# SUNDRY NOTICES AND REPORTS ON WELLS

2. Name of Operator Chevron U.S.A				8. Well Name and No. LENTINI 1 FED 5
3a. Address 6301 Deauville BLVD	. IIIC.	3b. Phone No. (include area coa	la)	9. API Well No. 30-015-27565-00-S1
Midland, TX 79706  4. Location of Well (Footage, Sec., T.,	R. M. or Surnou D			10. Field and Pool or Exploratory Area HERRADURA BEND
SEC1 T23S R28E SENW	ac,m., or survey Description)			11. Country or Parish, State EDDY COUNTY, NM

### Lentini 1 Federal #005 Short Procedure

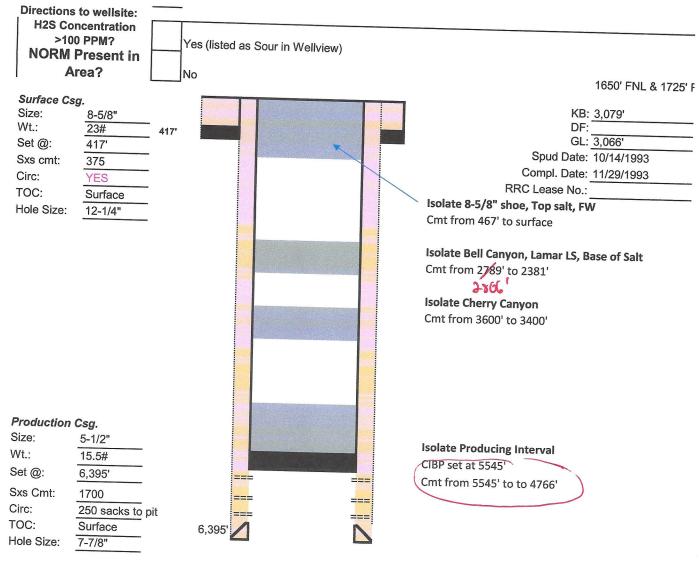
- 10. MIRU wireline and lubricator. Set depth for CIBP at 4700.
- 11. TIH with pressure tested workstring and tag CIBP at 4700'. 5545
- 12. Isolate Brushy Canyon producing interval via CIBP and cement

- a. Spot 31 sacks Class C cement from 4700' to 4500' 5545' + 4766' 80 5x
  - a. Pressure test on CIBP is required. If achieve successful pressure test, request permission from BLM to waive subsequent WOC times.

- b. Minimum length of cement is 100' above mech. barrier = 4600' 5445
  - c. Cement volumes include 10% excess per 1000' depth
- 13. Isolate Cherry Canyon

- 10. MIRU wireline and lubricator. Set depth for CIBP at 5545'.
- 11. TIH with pressure tested workstring and tag CIBP at 5545'.
- 12. Isolate Brushy Canyon producing interval via CIBP and cement

- a. Spot 80 sacks Class C cement from 5545' to 4766'
  - a. Pressure test on CIBP is required. If achieve successful pressure test, request permission from BLM to waive subsequent WOC times.

- b. Minimum length of cement is 100' above mech. barrier = 5445'
  - c. Cement volumes include 10% excess per 1000' depth
- 13. Isolate Cherry Canyon
  - a. Spot 29 sacks Class C cement from 3600' to 3400'

### Proposed WBD

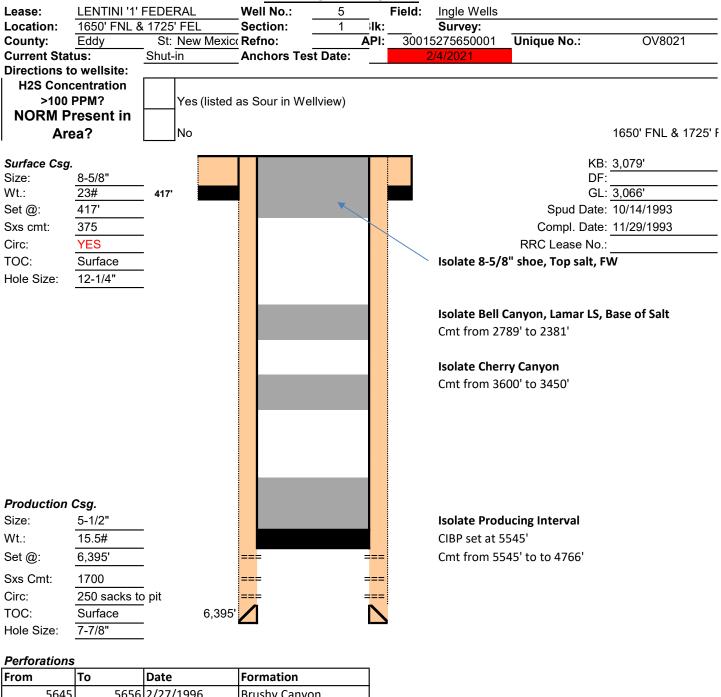
- b. Minimum tag depth 3500' (100' above formation top)
- 14. Isolate Bell Canyon, Lamar LS, base of salt
  - a. Spot 54 sacks Class C cement from 2806' to 2381'
